SB-10046779-3677

SI M17 06 12
Cooling Systems

Service Action: Retrofit of the Engine Coolant Temperature Sensor

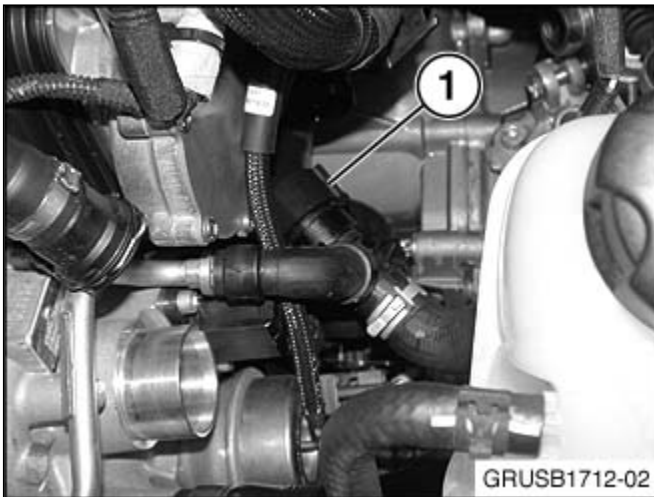
Remove the fresh air intake tube and the intake tube from the air box to the turbo to gain access to the coolant hose.

Remove the coolant hose (1). This hose will not be reused.

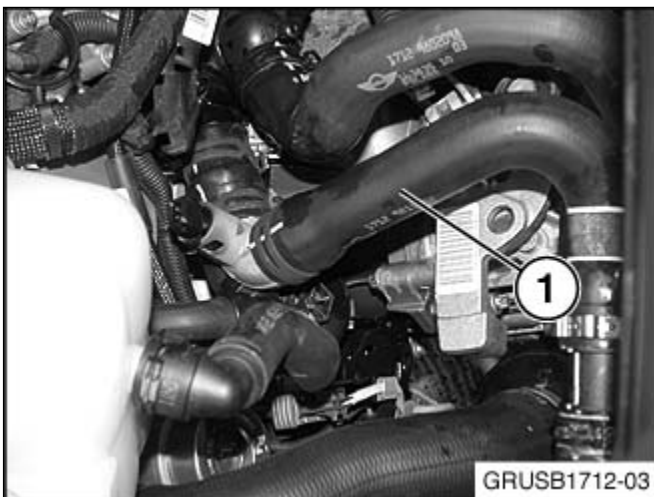
N18 engine only! Install spacer P/N 64 53 7 578 707 (1) on the coolant line as shown.

Note: The spacer needs to stay in this position when installing the new coolant hose P/N 17 12 7 647 004 (next step).

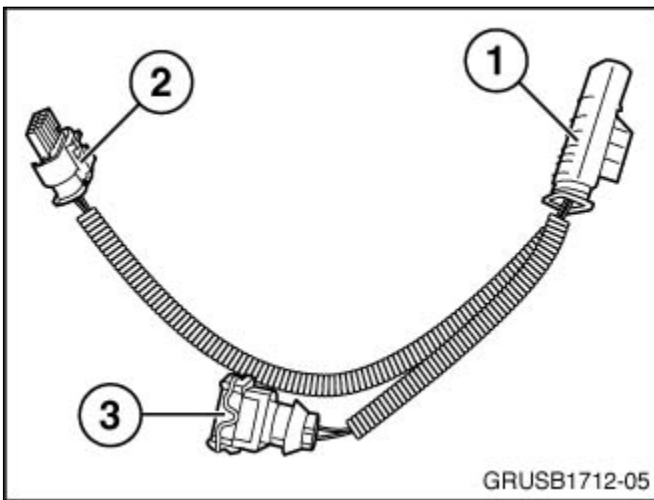
Install the new coolant hose with sensor P/N 17 12 7 647 004 (1).

Unplug connector X6279 from the engine thermostat (1).

Plug connector X6279 into the 4-pin male connector (1) of adapter harness P/N 12 51 7 647 200. Insert the 4-pin female connector (2) of the adapter harness into the engine thermostat. Plug the 2-pin female connector (3) from the adapter harness into the engine temperature sensor of hose P/N 17 12 7 647 004.
